Clinton Power Station, Unit 1  
Facility Operating License No. NPF-62  
NRC Docket No. 50-461

**Subject:** Additional Information Supporting the Request for License Amendment  
Related to Onsite Spent Fuel Storage Expansion

### Heat Load and Rack Drop Analysis Results Supporting the Request for License Amendment Related to Onsite Spent Fuel Storage Expansion

FIGURE WS-1011

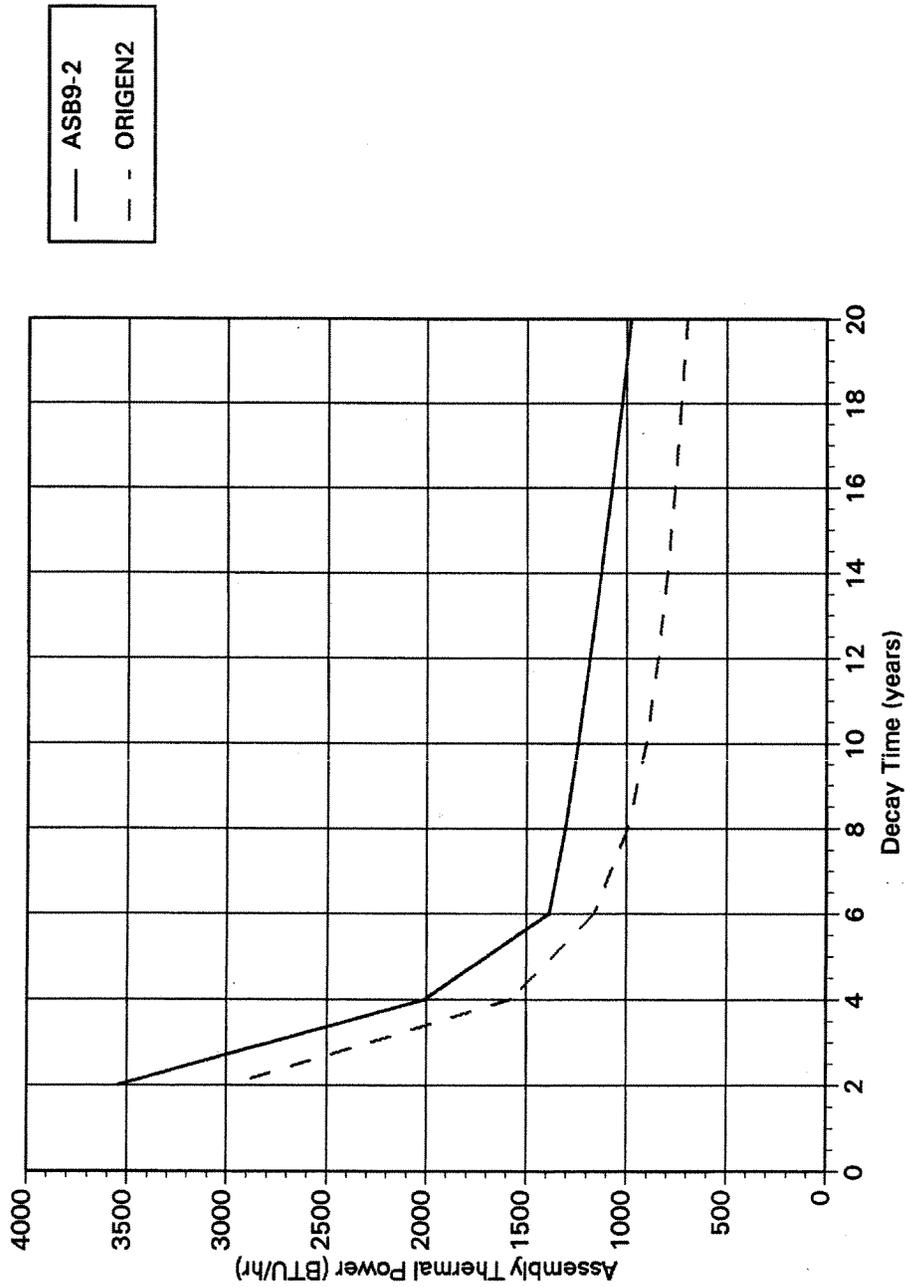
The expected agreement between ANSI/ANS 5.1 and ASB 9-2 is significant, as Holtec has performed a comparison between ASB 9-2 and computer code ORIGEN2 that was used to evaluate the CPS spent fuel storage expansion decay heat. This comparison of ASB 9-2 and ORIGEN2 was performed in 1995 for fuel from Millstone Unit 1, a BWR plant, so it is expected to be similar to the CPS fuel and operating conditions. The attached figure shows the comparison, which was performed for cooling times between 2 and 20 years. For cooling times on the order of years, ASB 9-2 significantly overestimates decay heat rates relative to ORIGEN2. This helps limit the increase in the background decay heat (i.e., from previously discharged fuel assemblies) that results from the increase in the number of stored fuel assemblies.

If qualitative extrapolation is applied at 2 and 20 years of cooling, the decay heats from ORIGEN2 are on the order of 14% and 20% lower, respectively, than those from ASB 9-2. While the reduction in the decay heat difference certainly does not change linearly with cooling time, we can estimate that a reduction at very low cooling times on the order of 4% to 5% is not unrealistic. As noted above, since the fuel transfer rate change accounts for approximately 3.8 MBtu/hr of the observed decay heat difference, the remainder (about 2.4 MBtu/hr) is due to the decay heat calculation methodology. This represents a reduction in decay heat of approximately 5%.
